LOT 147 BELLS CROSSING SUBDIVISION

LOT 147
BELLS CROSSING SUBDIVISION
MOORESVILLE, NC
IREDELL COUNTY

SOIL/SITE EVALUATION
***for* ON-SITE WASTEWATER SYSTEM**
(Complete all fields in full)

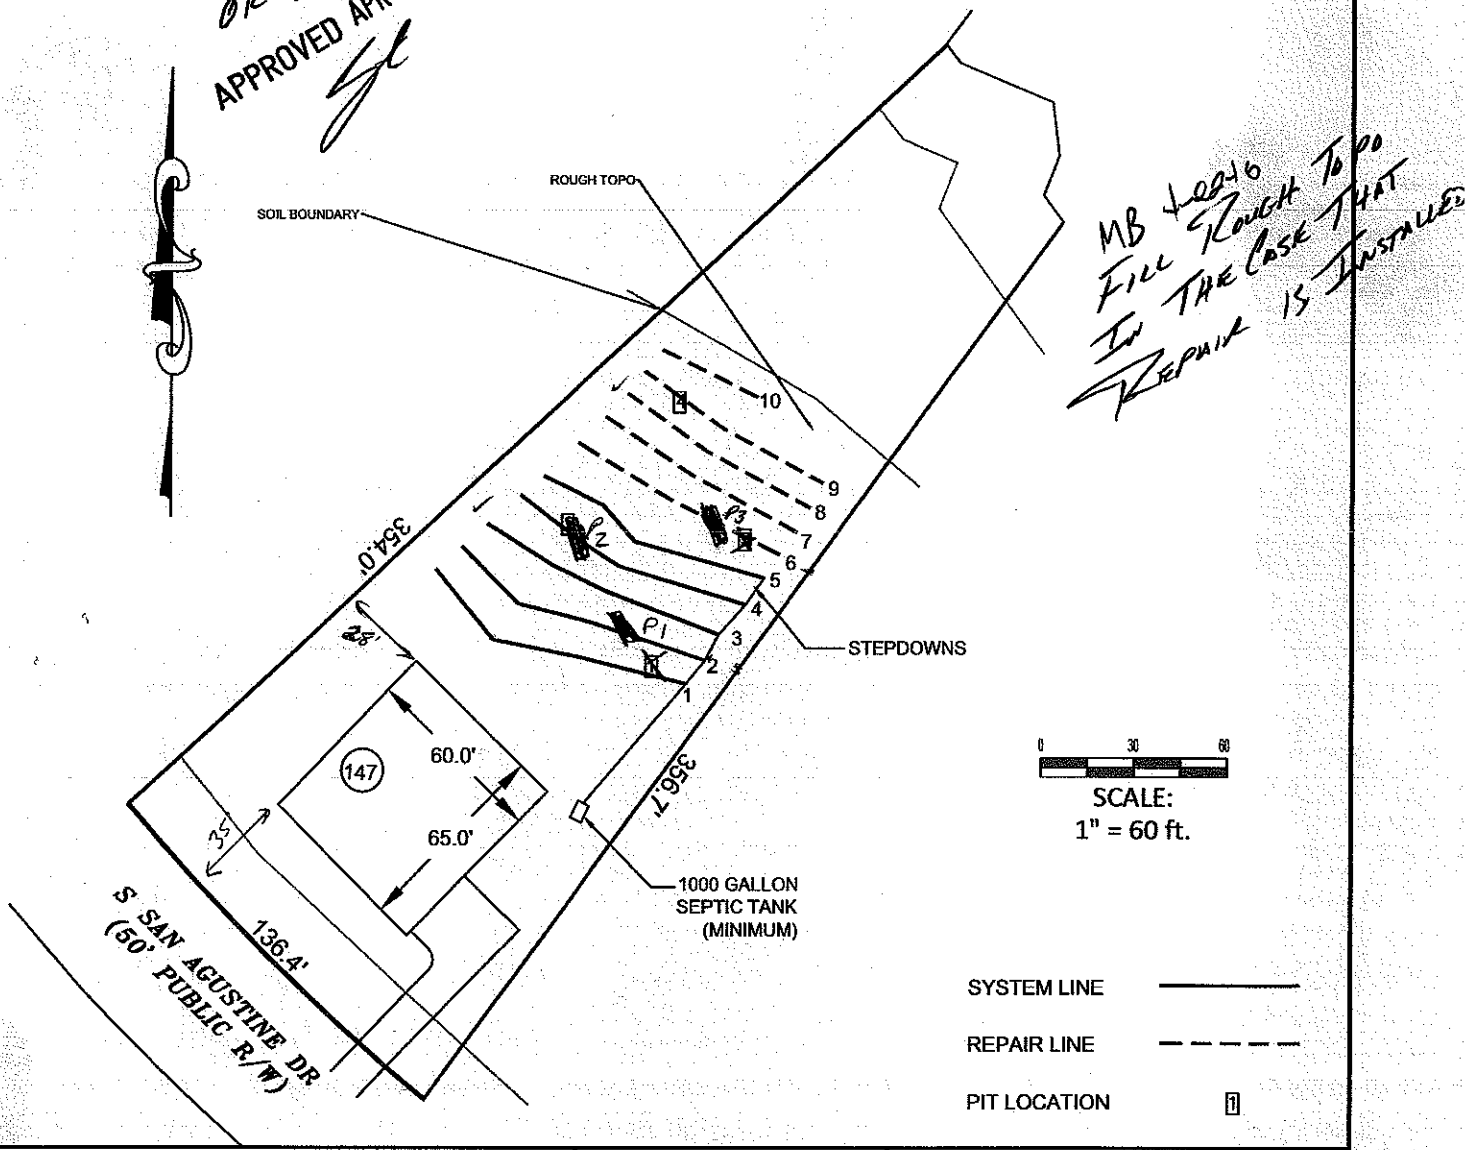
4-BEDROOM LPP FED PANEL BLOCK REPAIR
LINES 6-10 TOTAL 314 LINEAR FEET
LTAR ~~0.3~~ .275 MB 4-22-16
50% REDUCTION

MB 4-22-16
FILL TROUGH TO DO
IN THE CASE THAT
REPAIR IS INSTALLED

OK IC&D
APPROVED APR 21 2016
